Turbo HD DVR V3.4.90 build170205 Release Notes (2017-02-15)

Firmware Basic Information	Firmware Version:	v3.4.90 build170205
	SDK Version:	V5.2.5.40_build20161102
	Play Library (PlayCtrl.dll)	6.2.0.3
	player	7.3.0.74
	Web version	V4.0.1 build161019
	Client version	V2.5.4.1 build20161121

Reason of Upgrade

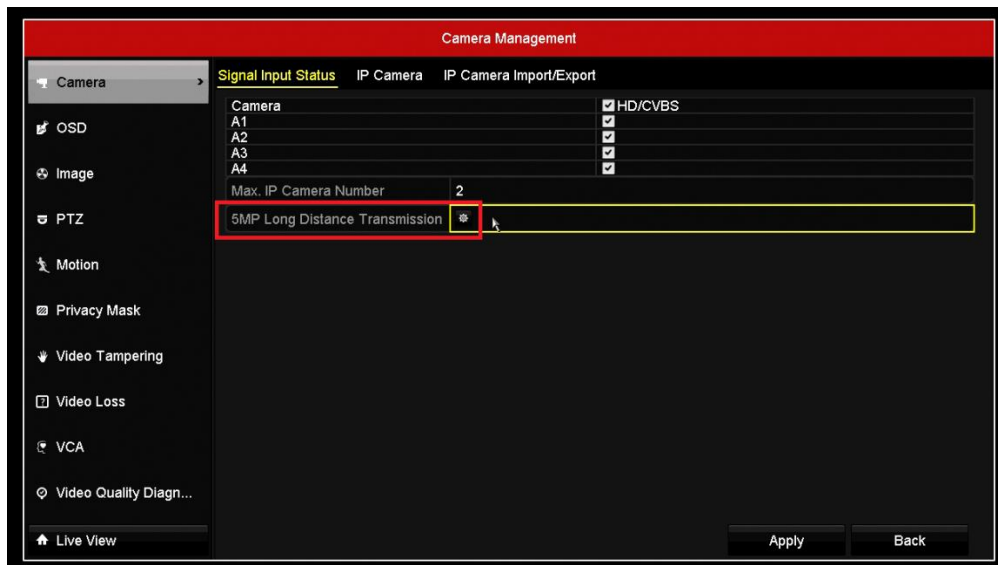
- i. Newly release F/S series DVR:
 - 1) F/S series DVRs newly support 5MP TVI cameras access, meanwhile support 5 in 1 functions, (TVI/AHD/CVBS/CVI/IPC) cameras self-adaptive access.
 - 2) Newly support **5MP long Distance Transmission** function on *Camera Management->Camera->Signal Input Status*. Each channel can be enabled separately. When this function is enabled, the maximum transmission distance can be up to 800m.

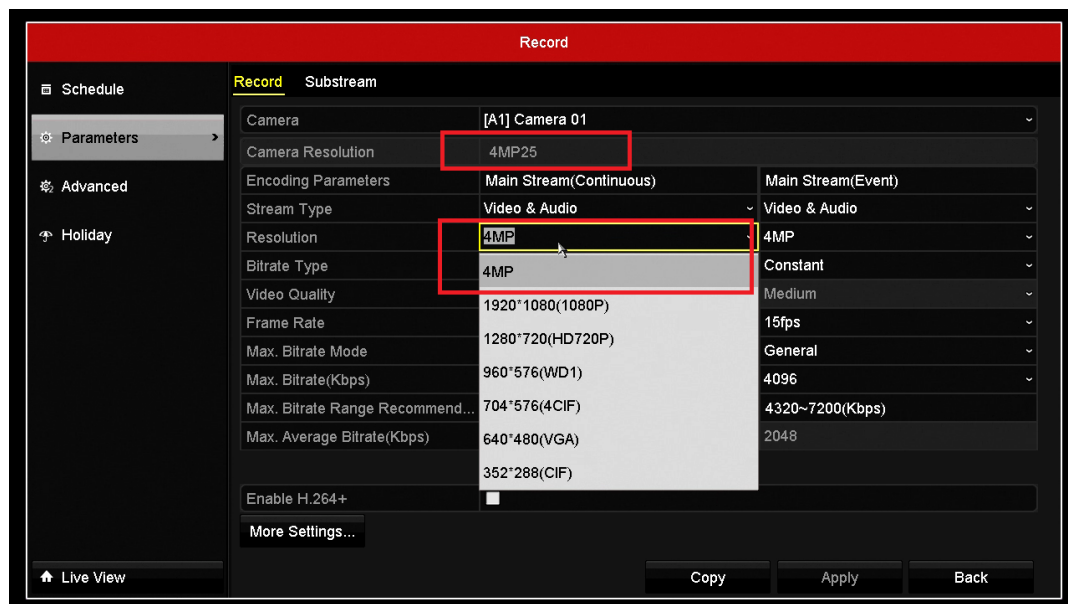
- ii. The recording resolution and frame rate of DVR analog channel can be self-adaptive according to the signal input.

The default main stream recording resolutions are 5MP/4MP/3MP/1080P/720P/WD1/4CIF/VGA/CIF. When connected with certain signal, the maximum resolution is consistent with resolution of signal input. For example, when connected with 4MP camera, 5MP recording resolution can't be supported; when connected with 3MP camera, 5MP and 4 MP recording resolution can't be supported.

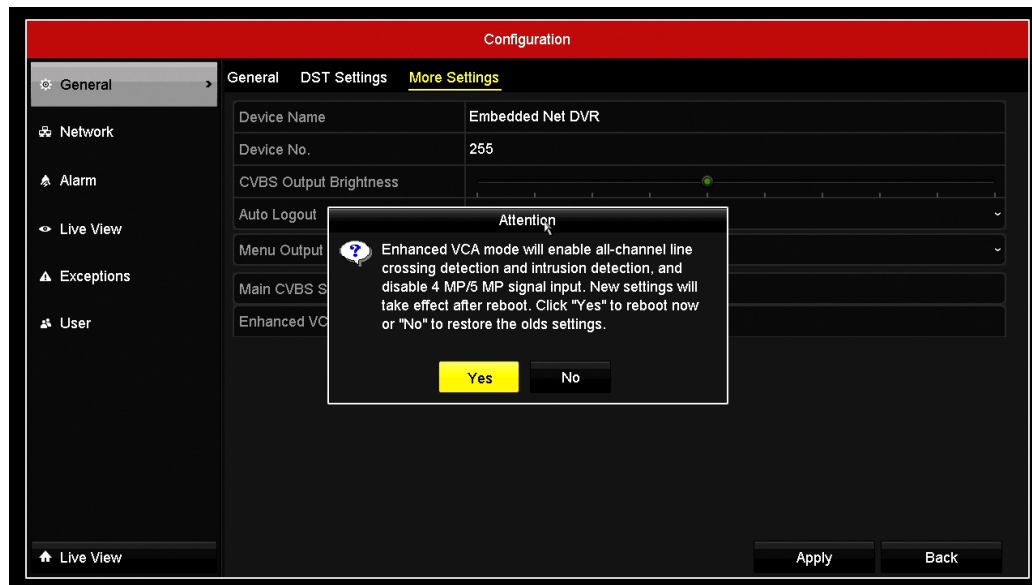
- iii. 4MP/5MP signal access is conflicted with "Enhanced VCA" function. When "Enhanced VCA" function is enabled, 2K/4K HDMI output of DVR is not supported and 4MP/5MP cameras can't be accessed.

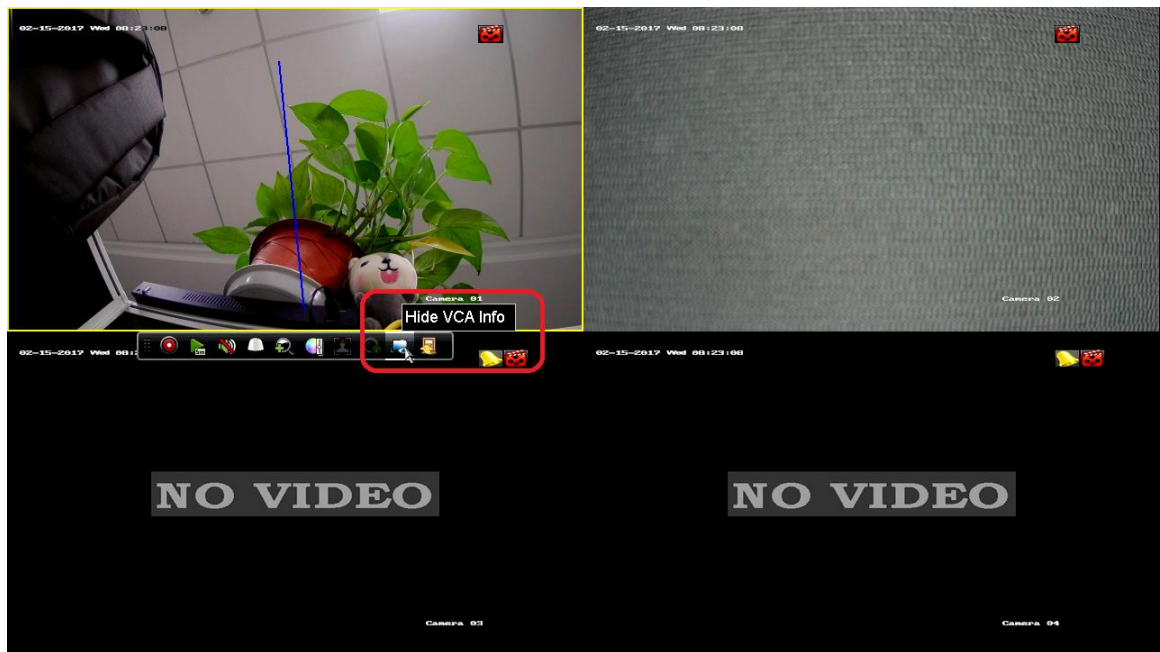
v. Support **displaying the VCA information** on the **analog channel** when previewing.

- 1) Left-click the button on the live view window to display VCA information, and left-click again to hide. Support showing target box and rule box at the same time. Only one channel can be used for displaying VCA information at one time.
- 2) Support displaying VCA information under single screen model or multi-screen model.
- 3) Main-monitor output has this function, while auxiliary-monitor output not.

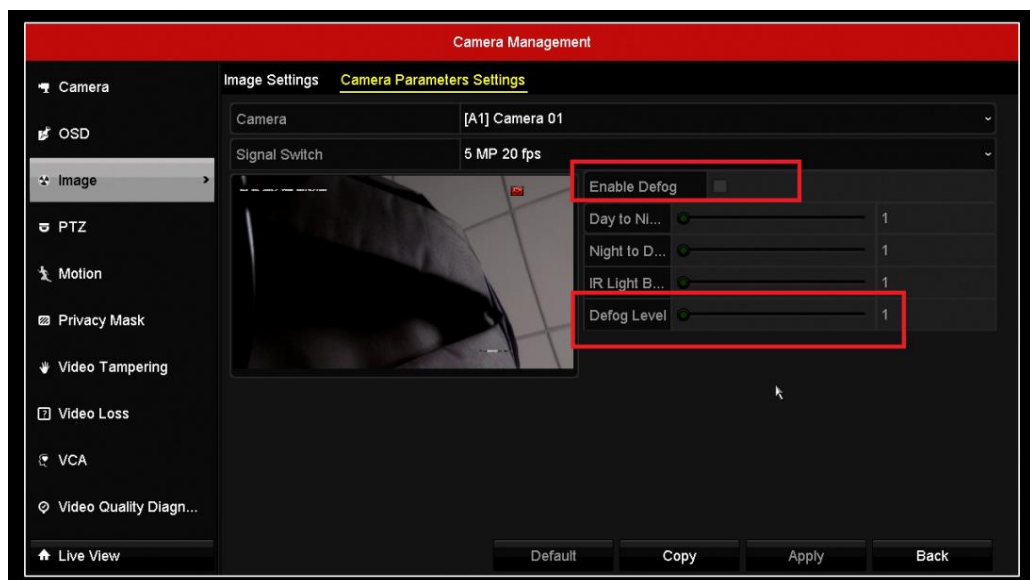
- vii. Update of coaxial function.
 - 1) Support TVI/CVI/AHD signal coaxial control function, the protocol name is changed to **UTC (Coaxitron)**.
 - 2) Support **all channel** of Hikvision TVI camera upgrading at one time, which used to be only one channel upgrading at one time.

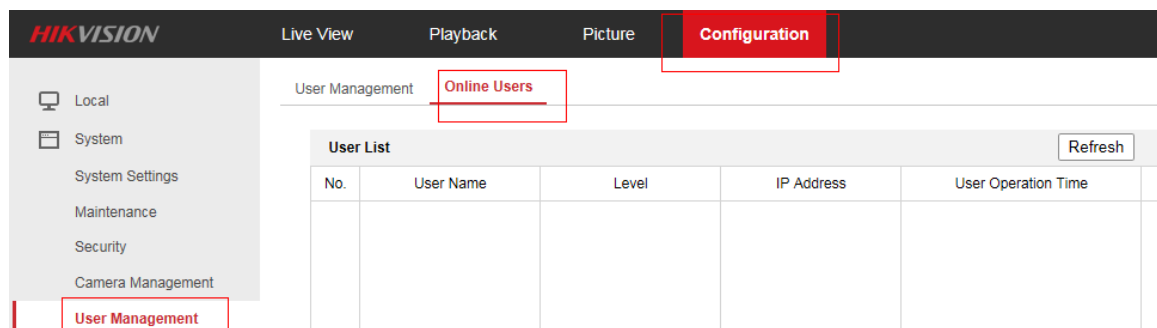
- 3) Newly support configuration of TVI camera **Defog** function. Defog Level is configurable on *Camera Management->Image->Camera Parameters Settings*.

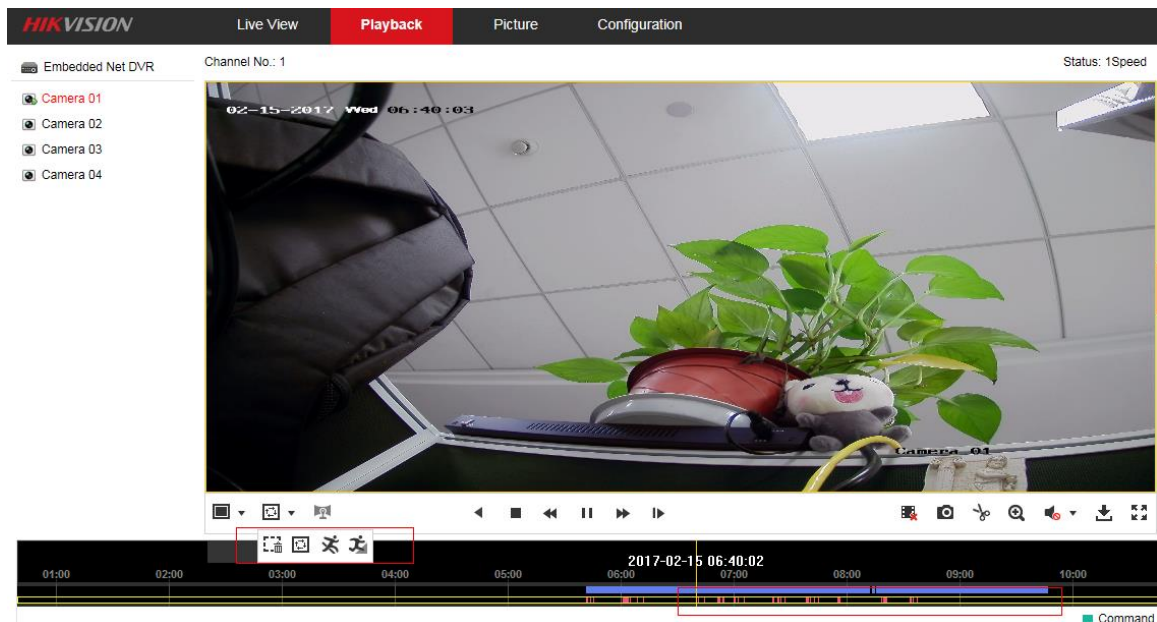
- ix. All VCA events newly support PTZ linking action.

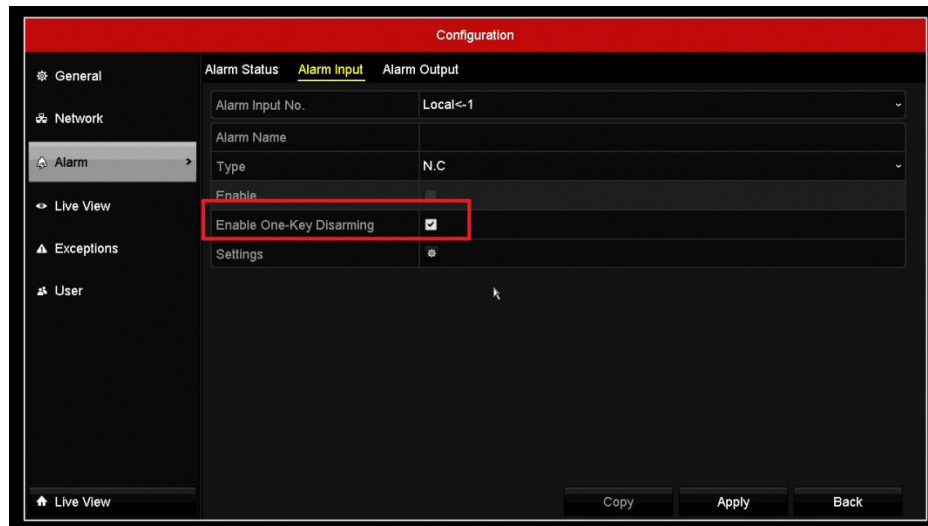
- x. Newly support VCA search function of remote playback. Supported VCA type: Motion Detection, Intrusion Detection, Line Crossing Detection.
